Addendum No. 1

To: All Contractors
Date: January 11, 2018
Re: Environmental Services Facility – Phase 2
1550 Progress West Ln
O'Fallon, Missouri

SHEET
E1

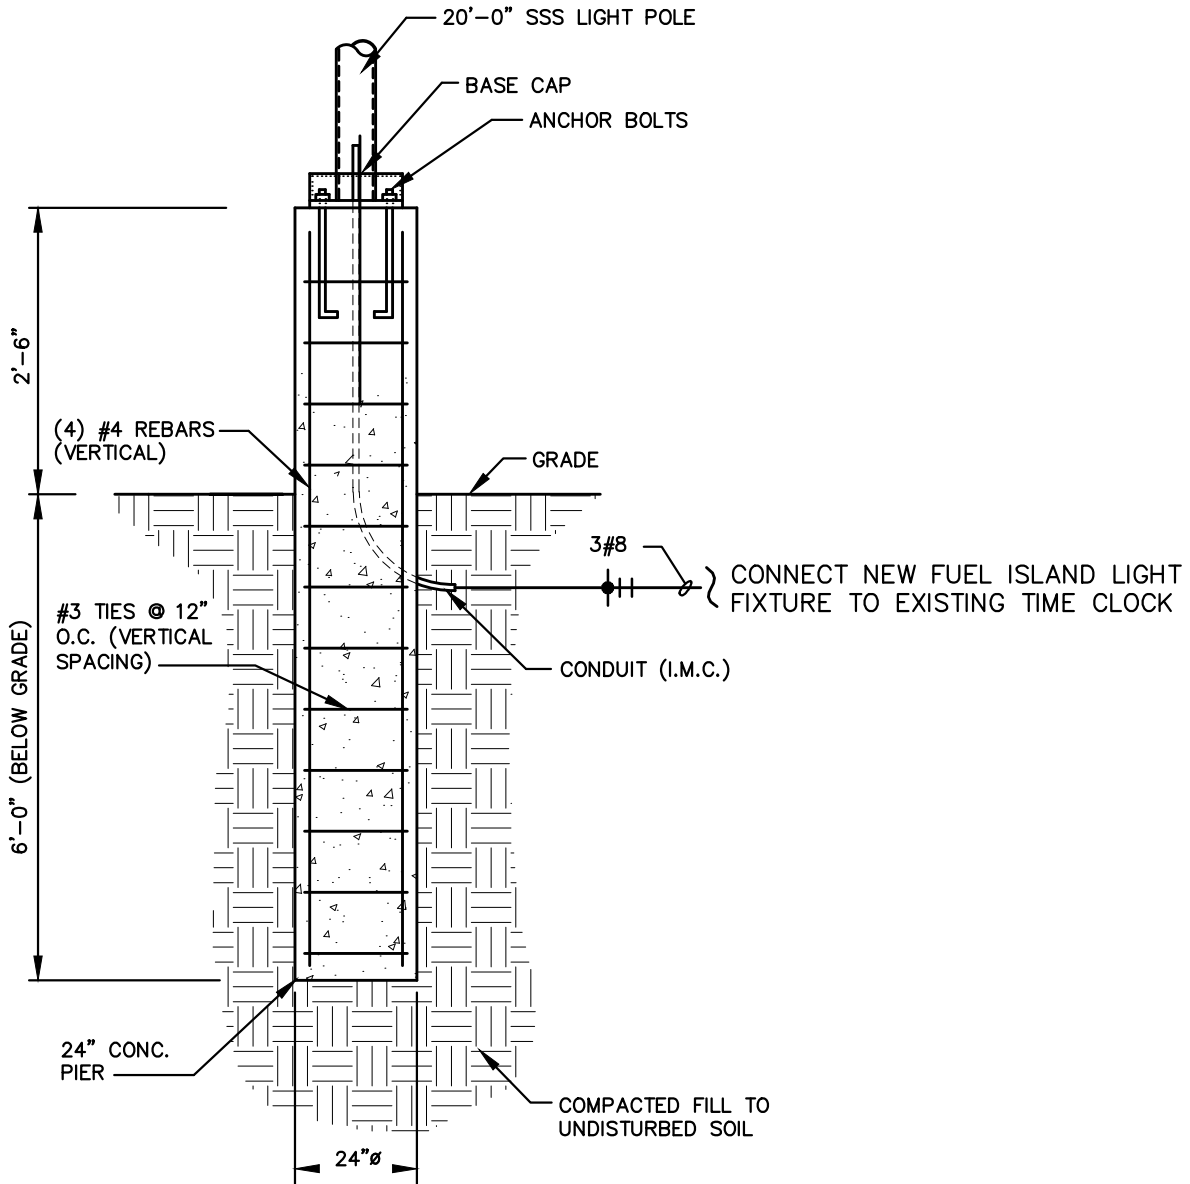
1. Sheet 4 of 10, Site Plan (No Drawing Issue)
 - a. Revised the new concrete depth from 7-inches to 8-inches. "New 8" concrete over 4" rock." Also see 8" Concrete Pavement Detail on sheet 9 of 10.
 - b. For bidding purposes, the three (3) electrical conduits are to be located per the Site Plan. For electrical connections, the existing electrical panels are located in the Southwest portion of the building.
2. Sheet 9 of 10, Details. (No drawing Issue)
 - a. There is one (1) Light/Light standard in the scope of work. Provide and install the same type of light/light standard as was installed in the recently completed Phase 1 project. See attached Light/Light Standard Detail.

1. Added two (2) new 8x11 Supplemental Sheets.
 - a. Sheet E1, Light / Light Standard containing the Light Fixture information and Pole Base Detail.
 - b. Sheet E2, General Electrical Requirements Notes.
